# HISTORIC AND DESIGN REVIEW COMMISSION

June 16, 2021

**HDRC CASE NO:** 2021-100  
**ADDRESS:** 415 MISSION ST  
**LEGAL DESCRIPTION:** NCB 946 BLK 2 LOT 22  
**ZONING:** RM-4,H  
**CITY COUNCIL DIST.:** 1  
**DISTRICT:** King William Historic District  
**APPLICANT:** Jake Jazdzewski/JAZDZEWSKI JAKE & MONICA  
**OWNER:** Jake Jazdzewski/JAZDZEWSKI JAKE & MONICA  
**TYPE OF WORK:** Relocation of garage structure, modifications  
**APPLICATION RECEIVED:** May 18, 2021  
**60-DAY REVIEW:** Not applicable due to City Council Emergency Orders  
**CASE MANAGER:** Stephanie Phillips  
**REQUEST:**

# JAZDZEWSKI RESIDENCE RESIDENTIAL REMODEL

**3 BACK ELEVATION - DEMO**  
SCALE: 1/4" = 1'-0"

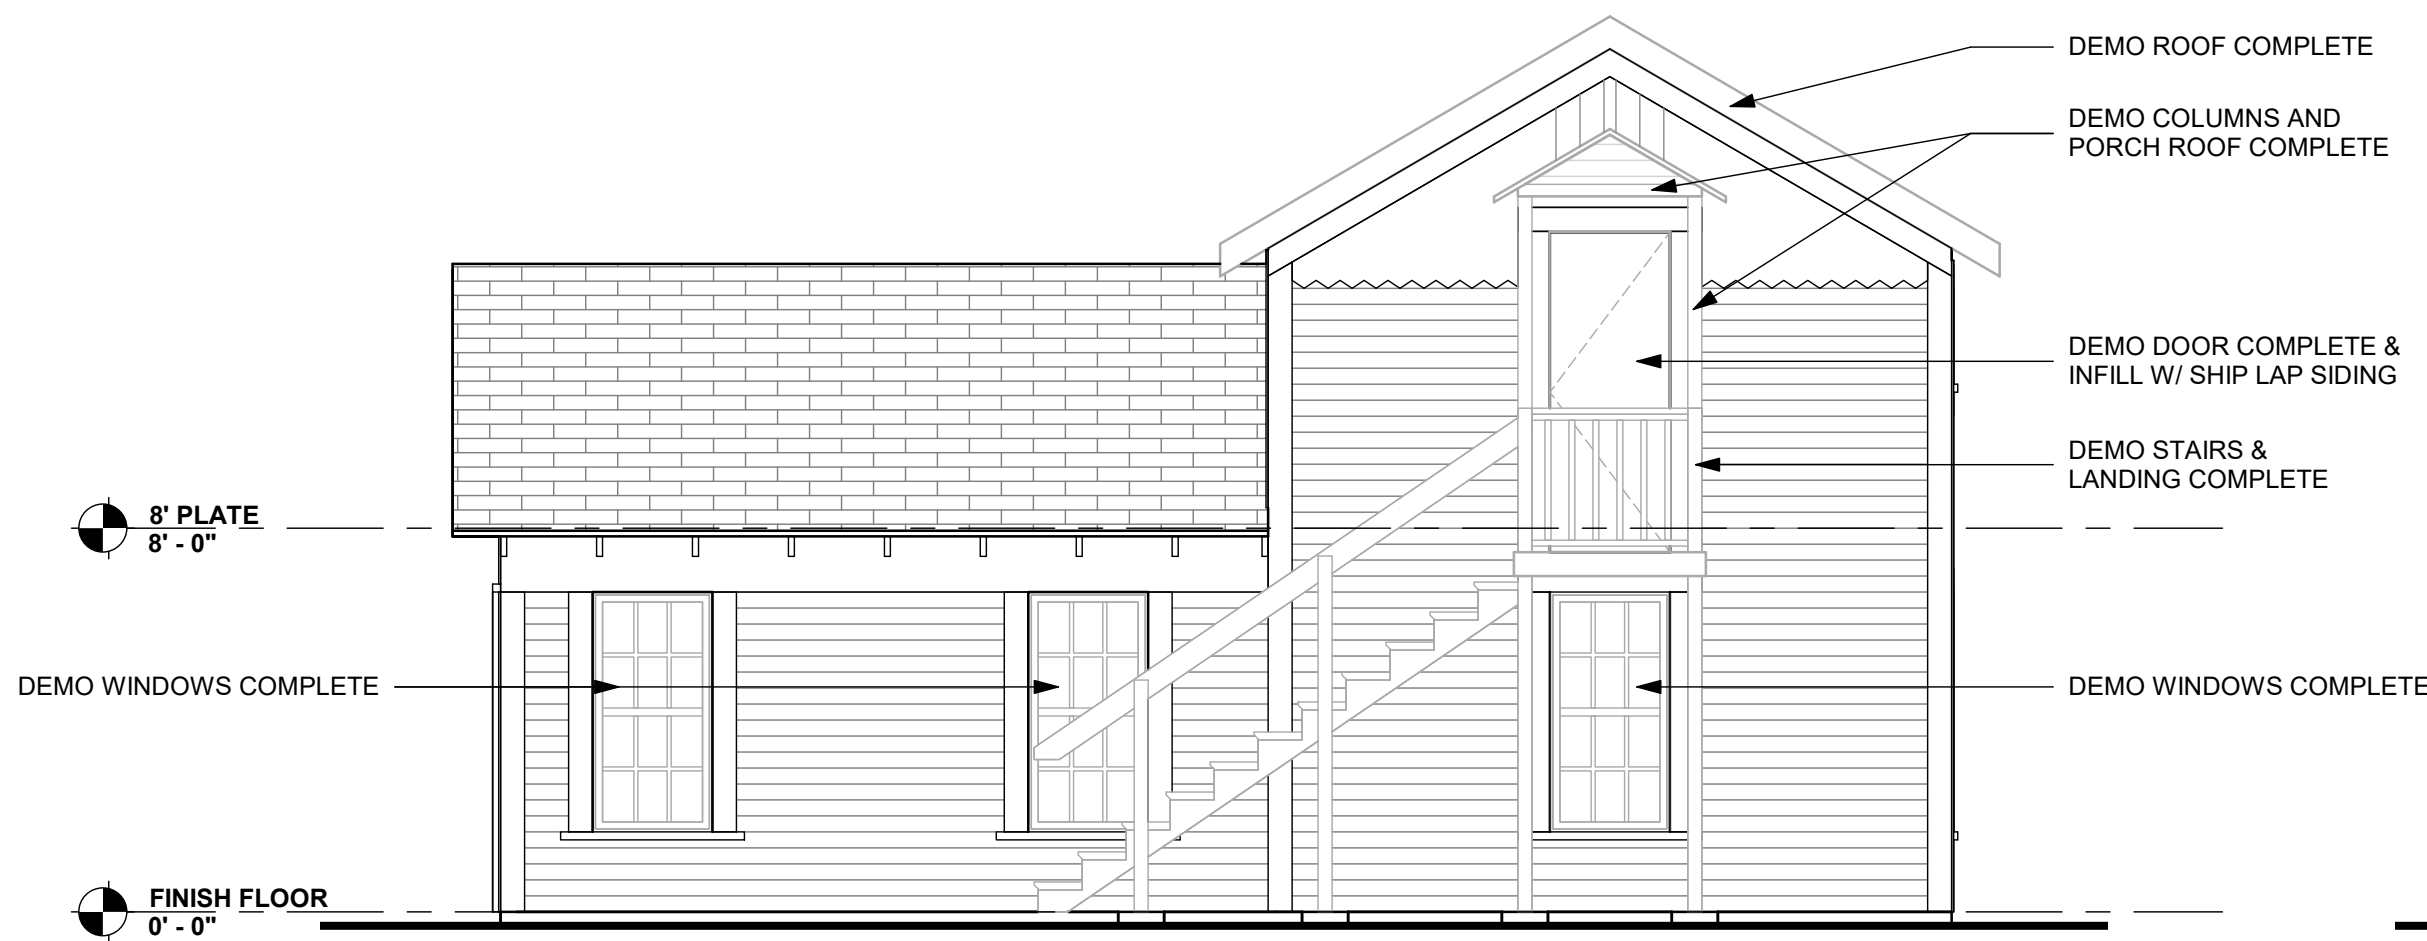
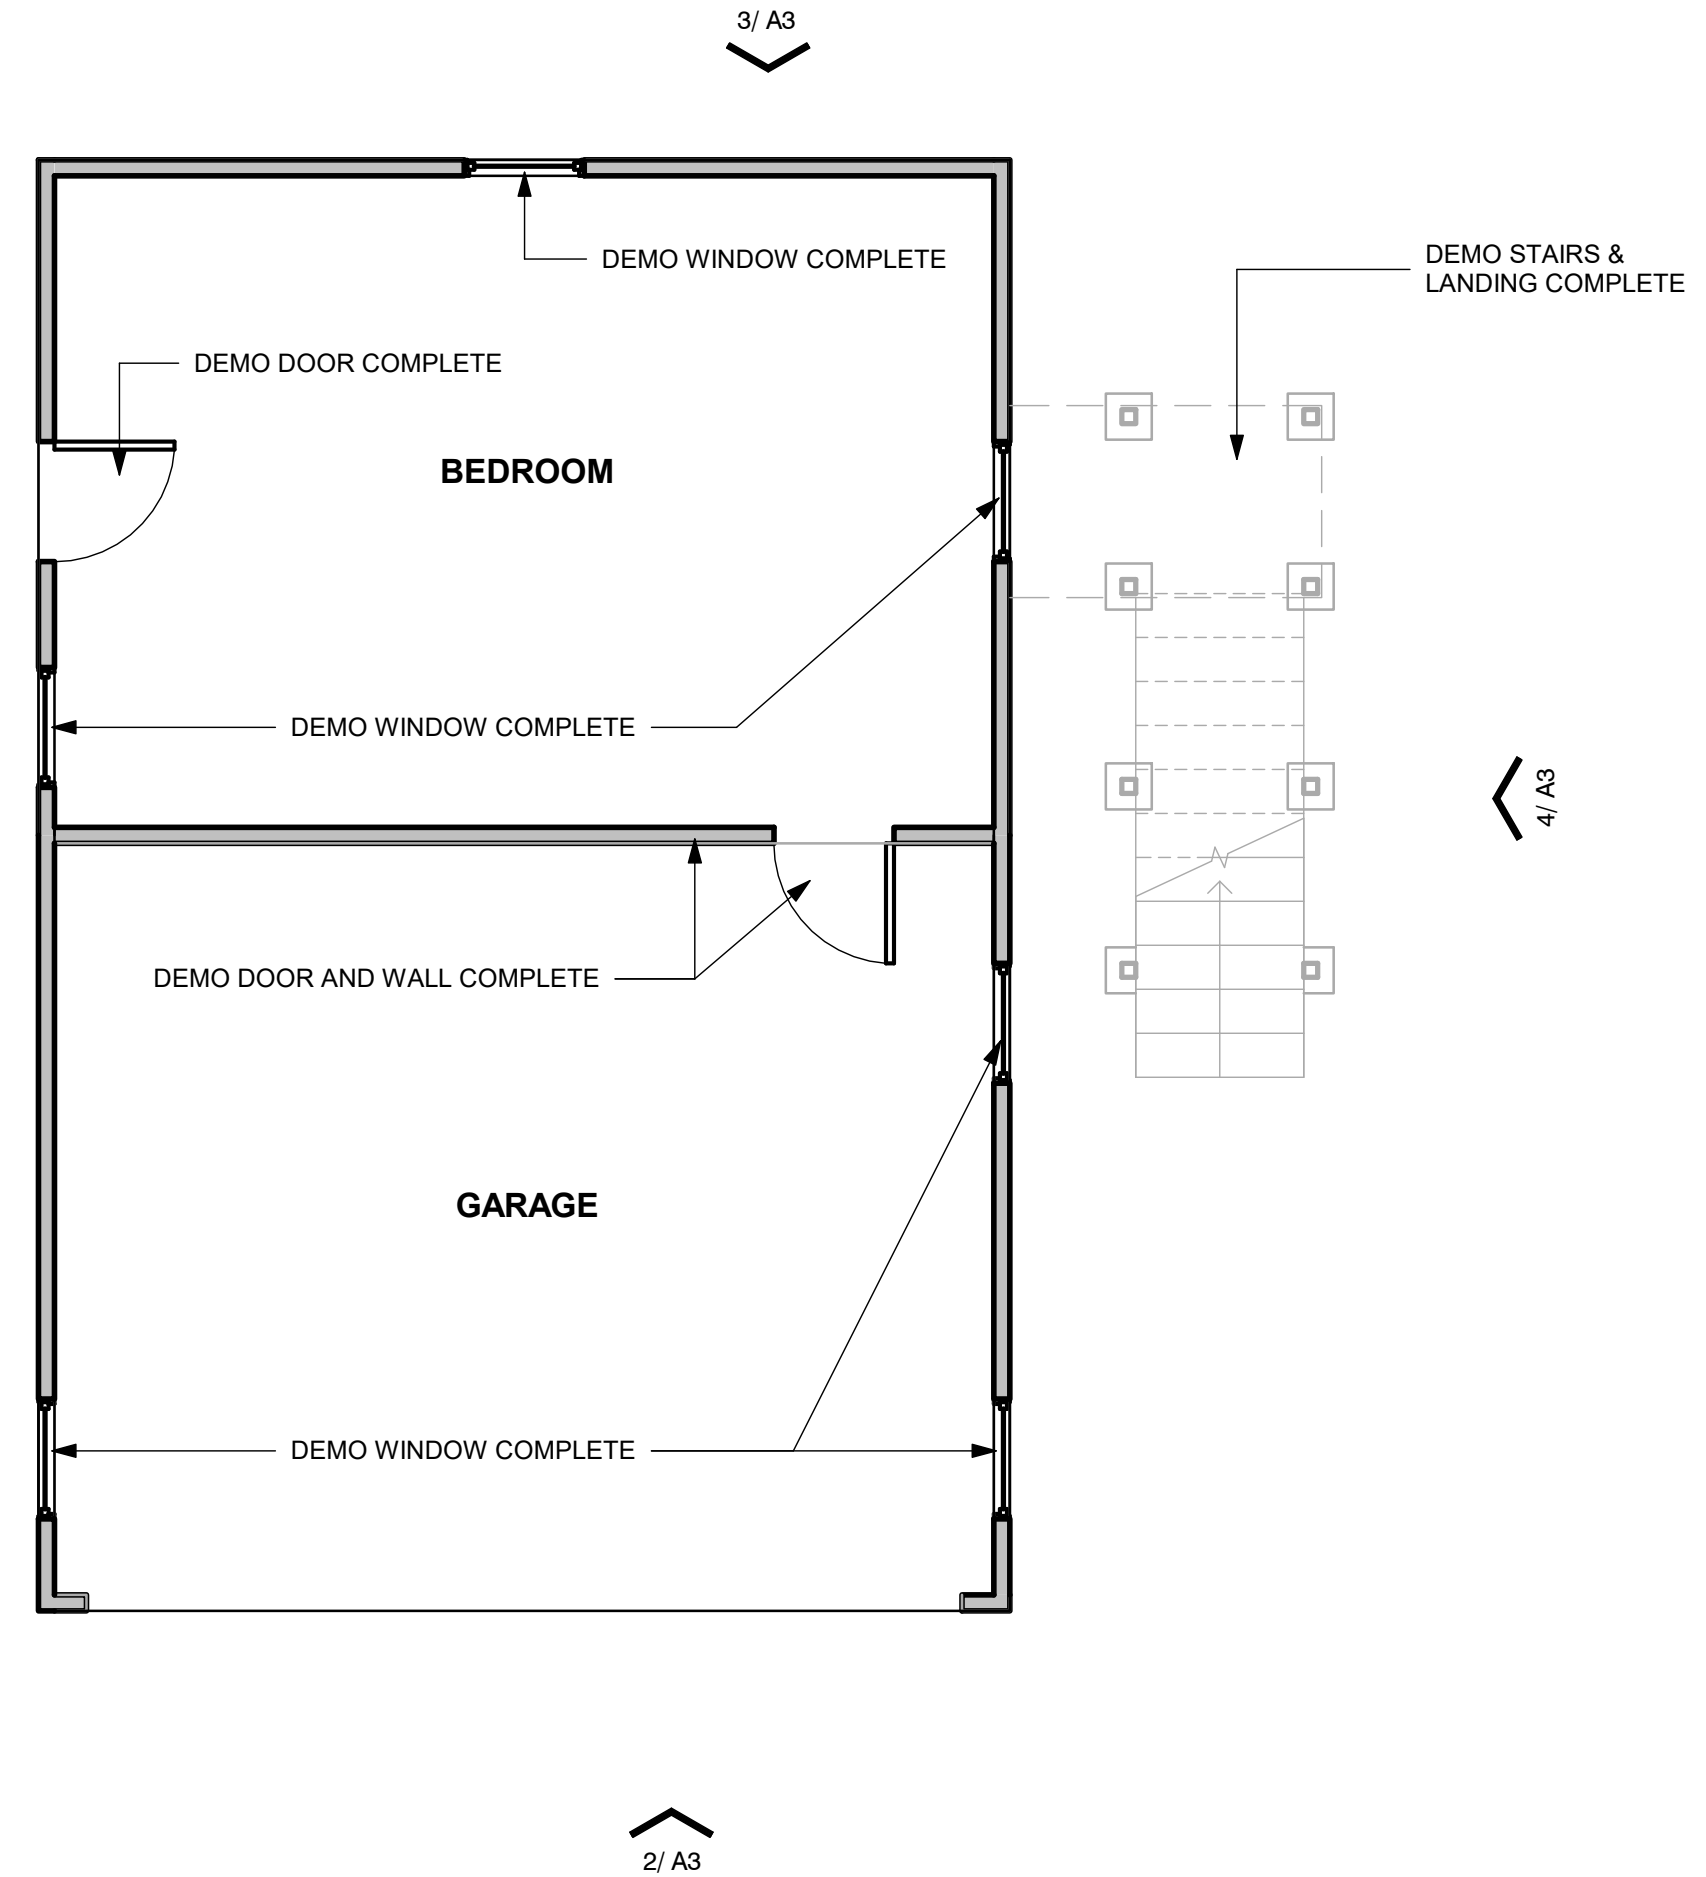
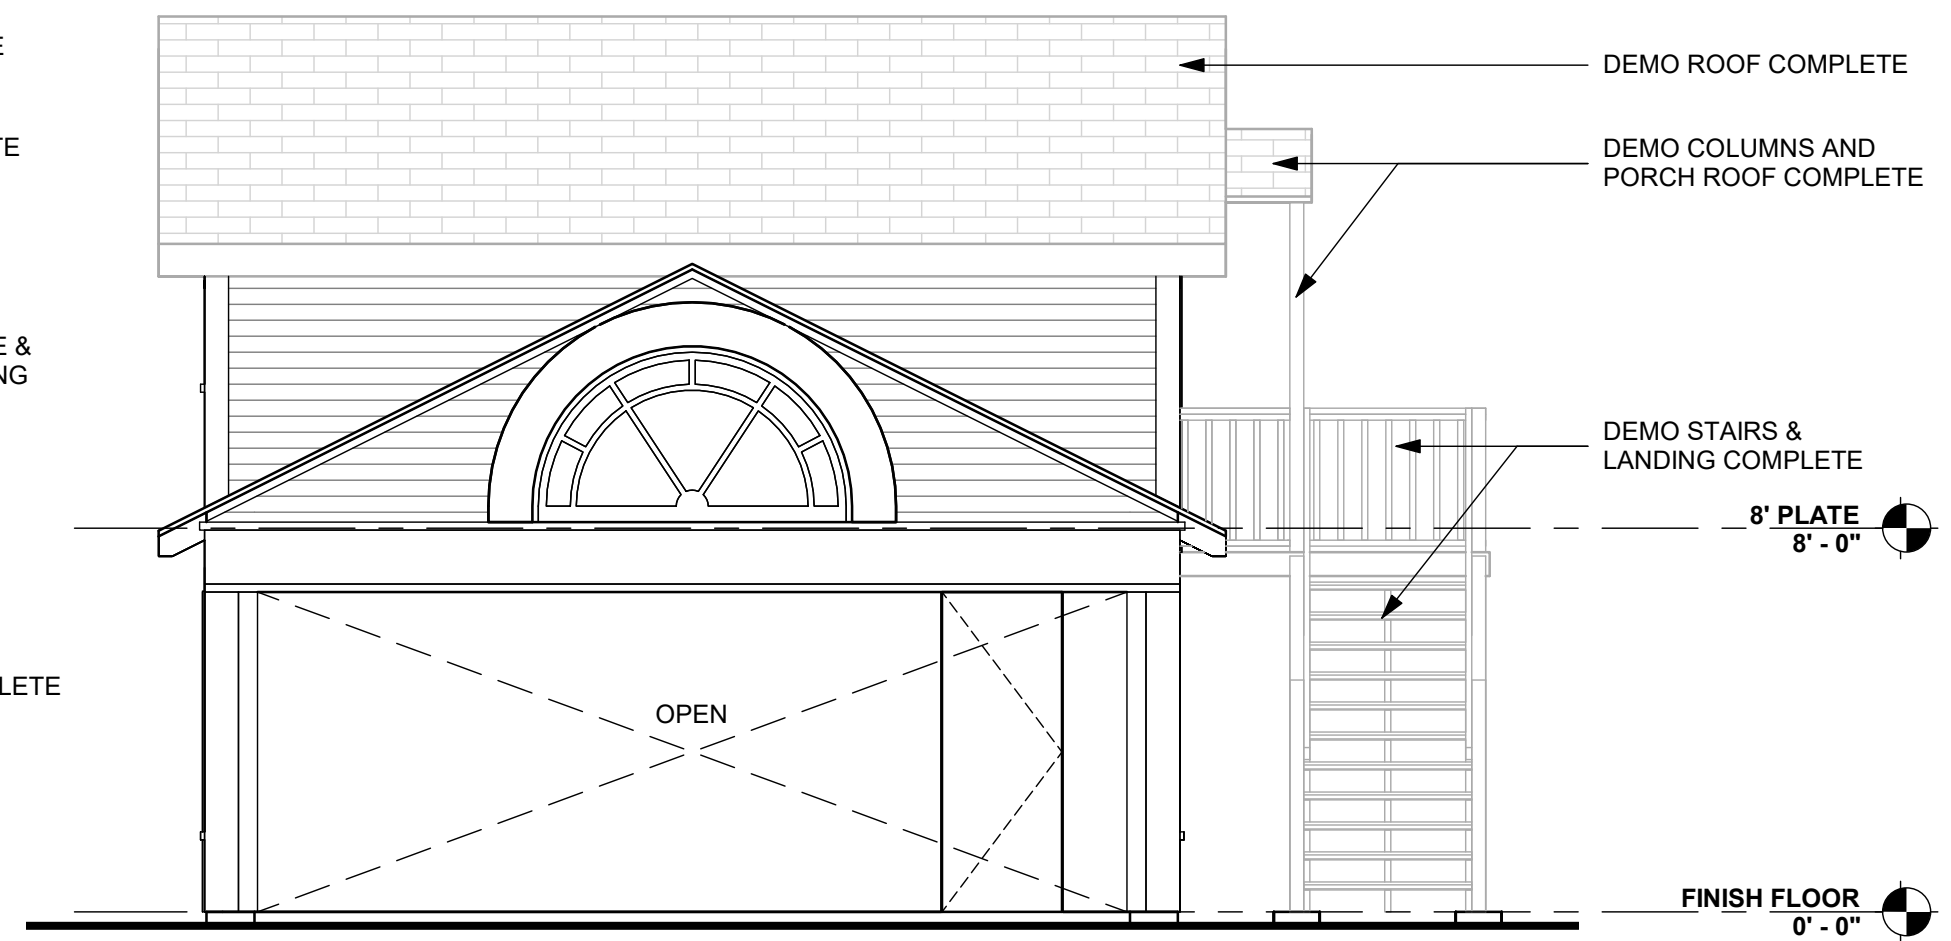
- d. STAIR REMOVAL – The applicant has proposed to remove an existing outdoor stair leading to the second story. The applicant has proposed to incorporate an interior staircase to address access and egress. Staff finds the stair removal acceptable.

- e. FENESTRATION MODIFICATIONS – The applicant has proposed to replace an existing second story door at the stair landing with a new window to match existing in terms of scale, proportion, configuration, and inset. The awning above the door will also be removed. Staff generally finds the request appropriate, but finds that the door should be retained and reused elsewhere on the structure, or stored on the property. Additionally, the applicant has proposed to remove an existing first floor window and enclose with siding on the back elevation. An existing second story window on this elevation will be retained. Staff generally finds the request acceptable based on its limited visibility from the public right-of-way and the retention of an additional opening, but finds that the window should be retained and reused elsewhere on the structure, or stored on the property. Staff also finds the addition of new sliding doors on an ancillary elevation to be appropriate.

- iii. That the applicant retains the existing windows and doors to be removed and reuses them in other openings on the structure, to include the replacement of windows deteriorated beyond repair if applicable, or keeps them onsite for future use as noted in findings e and f.
